Planning Division Report

May 9, 2025

Re: Application for Minor Variance A10-25-PC
Lot 38 on Plan 52, New Plan 811
3611 Firelane 12
Owner: Danny Leon
Agent: Craig Esposti, Willmott and Strickland Inc.

Site Plan • C.A.V. Application • 1:250
3611 Firelane 12, Port Colborne, ON • March 27, 2025

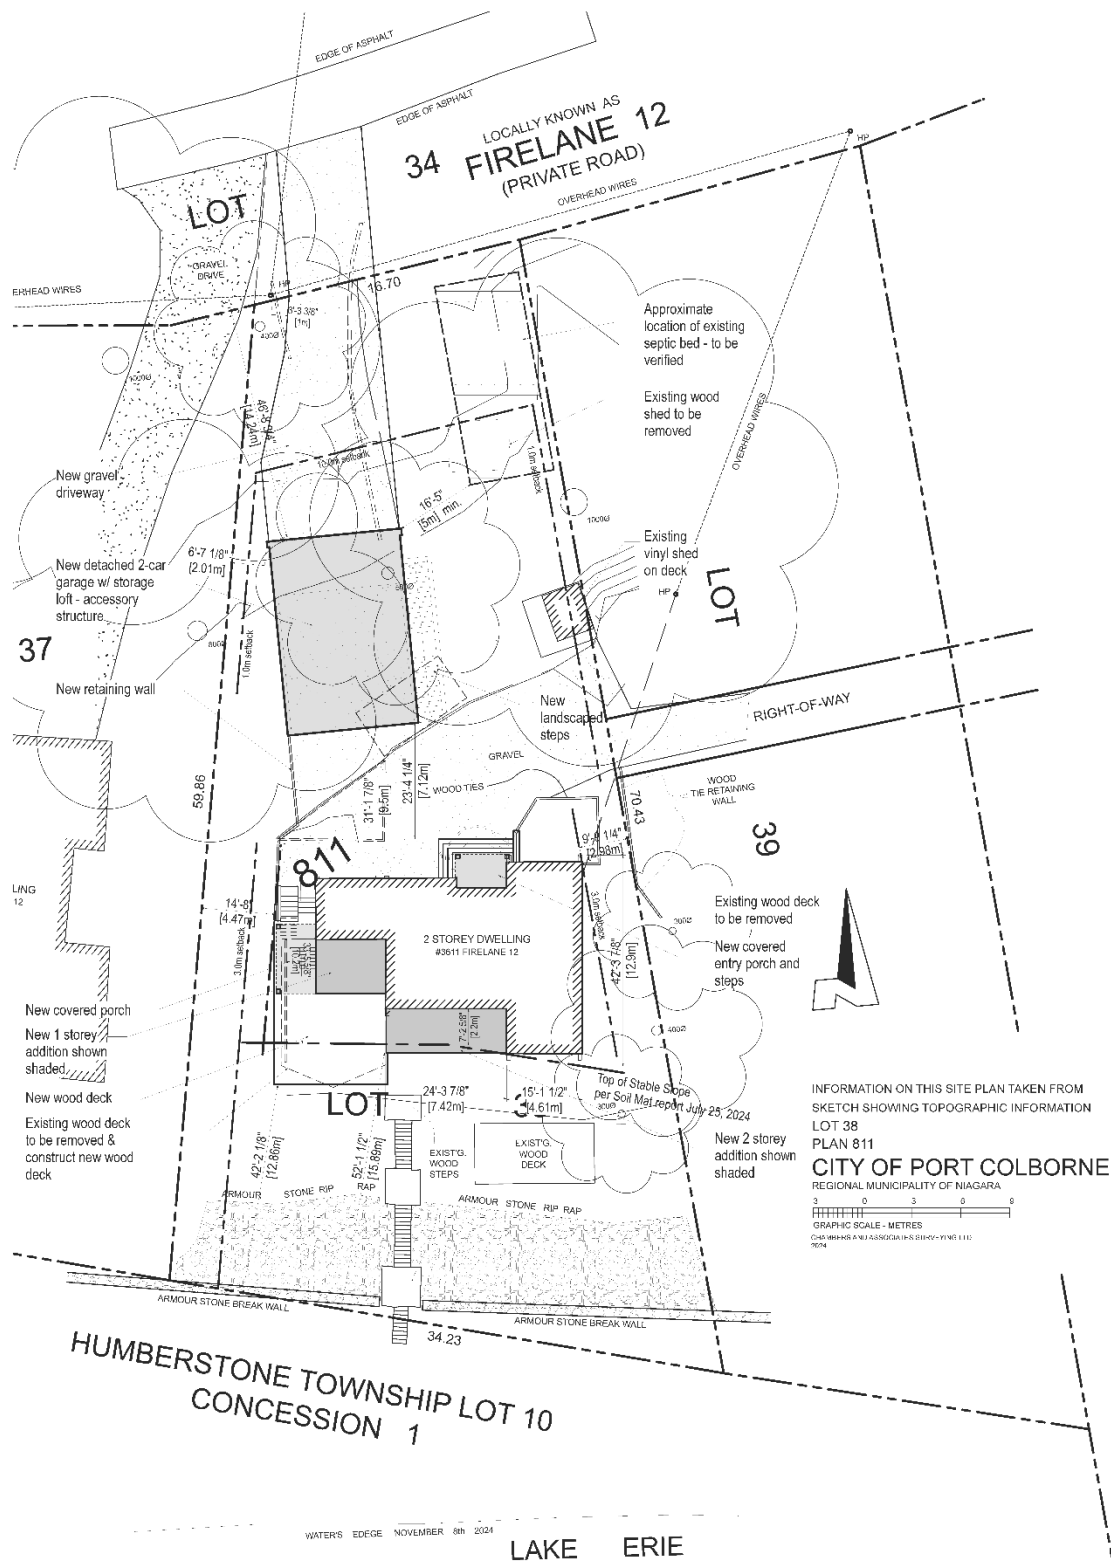
Due to the scope, nature and location of the proposed garage, a Tree Preservation Plan (TPP) will be required, to indicate any trees that need to be removed to allow for the construction of the garage, and appropriate mitigation measures to protect adjacent trees.

A private sewage system inspection and review is required, as it appears a bedroom and living space are proposed to be added. A septic design will likely be needed as it is unlikely the existing septic system can accommodate the increased capacity. A septic permit will likely be required prior to a building permit being issued.

The proposed addition extends beyond the Stable Slope limit and, thus, is not supported by the NPCA; however, the NPCA could support a revised design which respects the Stable Top of Slope Allowance.

The NPCA recommends deferral of this application until the applicants provide a revised plan that no longer proposes any work beyond Lake Erie's Stable Top of Slope limit.

The proposed addition to the dwelling that the NPCA objects to is at the southernmost building wall of the dwelling, which would extend beyond the stable slope limit. The NPCA recommends deferring the application until they revise their plan to propose works only within the stable top of slope limit.

1. The proposal is revised to ensure the addition is no longer proposed on an unstable portion of the slope, to the satisfaction of the NPCA staff.
2. A Stage 1-2 Archaeological Assessment is completed;
3. A Tree Preservation Plan is completed; and
4. An inspection is completed to determine whether the existing private sanitary service can accommodate the proposal, and if the existing system will not suffice, a new design of the septic system, to the satisfaction of Regional staff;
